## NOTICE OF VILLAGE BOARD MEETING

5. Review and consider Plan Commission's recommendation for Meadow View Dental plans on lot 4 in The Locks Business Park; approve if appropriate
6. Administrator, Public Works Director and Law Enforcement reports – accept and file

Re: Meadowview Dental – 544 Martineau Road  
Stormwater & Site Plan Review #1  
McM. No. C0006-09-26-00330.00

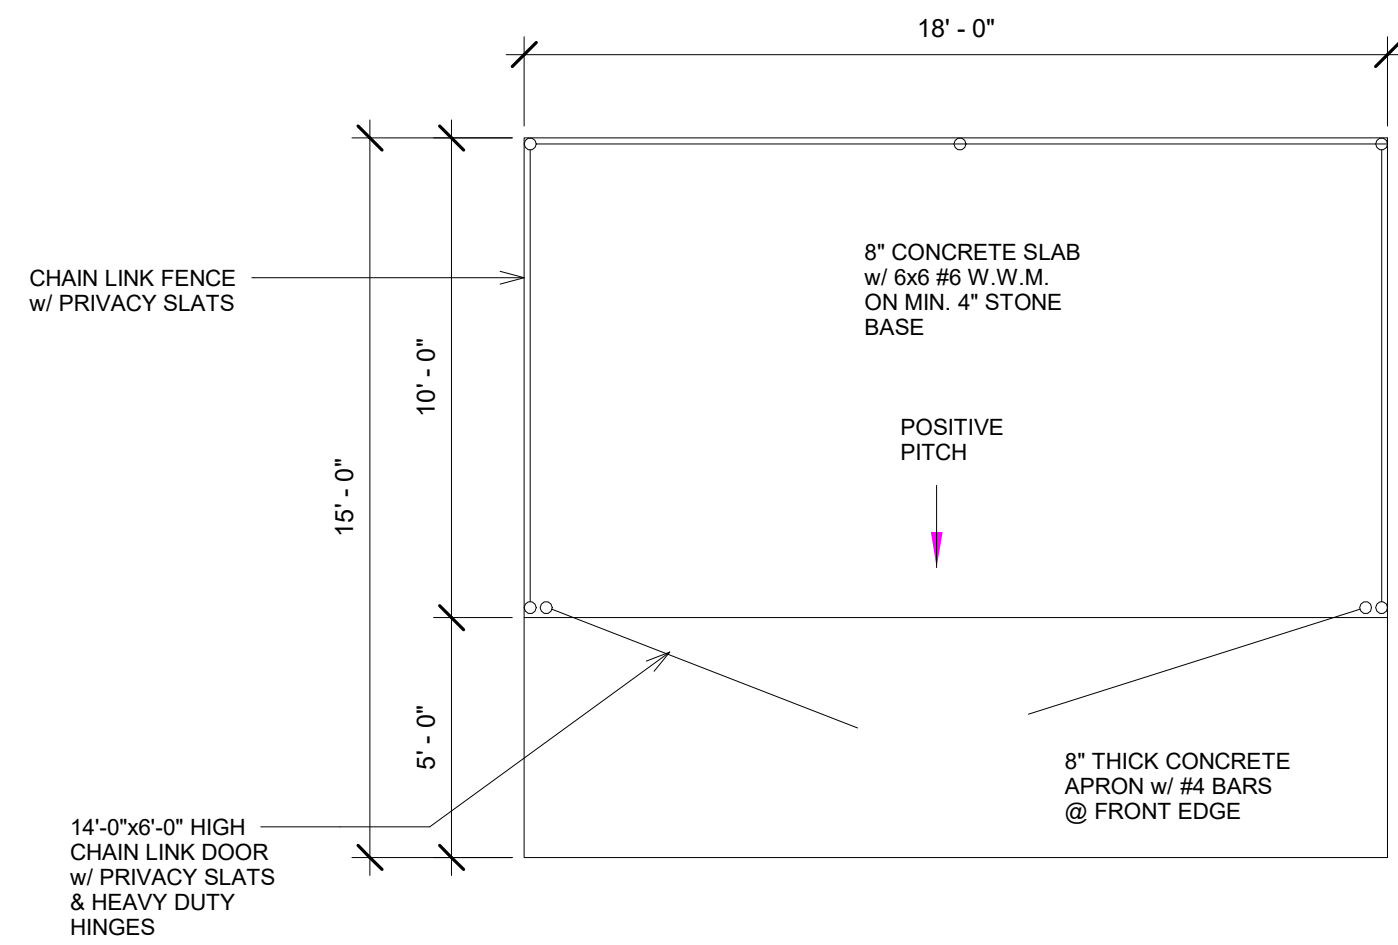
The proposed site demolition plan identifies sawcutting and removing the existing curb & gutter for the proposed driveways/aprons.

- The existing 4" thick sidewalk within the proposed driveway locations should also be identified to be removed. The site plan should show/call out the sidewalk being replaced with 6" thick concrete, similar to the new 6" thick concrete apron.

The submitted Landscaping Plan does include a good mix of trees, shrubs and plantings that seem appropriate for the site. However, there are no plantings proposed within the 15' Planting Easement along CTH "CE".

- Per the Village's Zoning Ordinance, a landscape buffer is required for properties adjacent to CTH "CE" per the requirements of § [580-14](#) and must be approved by the Planning Commission. It's up to Village Staff and/or Planning Commission if you want to require additional plantings within the 15' Planting Easement.

The submitted photometric/lighting plan does include some pole mounted lights within the parking lot.

- Per the submitted photometric plan, there will be minimal (0.1-0.2 footcandles) light dispersion on the adjacent parcel to the east. I searched the Village's ordinances for lighting requirements but could not find any. As such, this comment is for informational purposes and up to the Village if they'd like to see a revision to the photometric/lighting plan so there is zero light dispersion on the adjacent parcel.
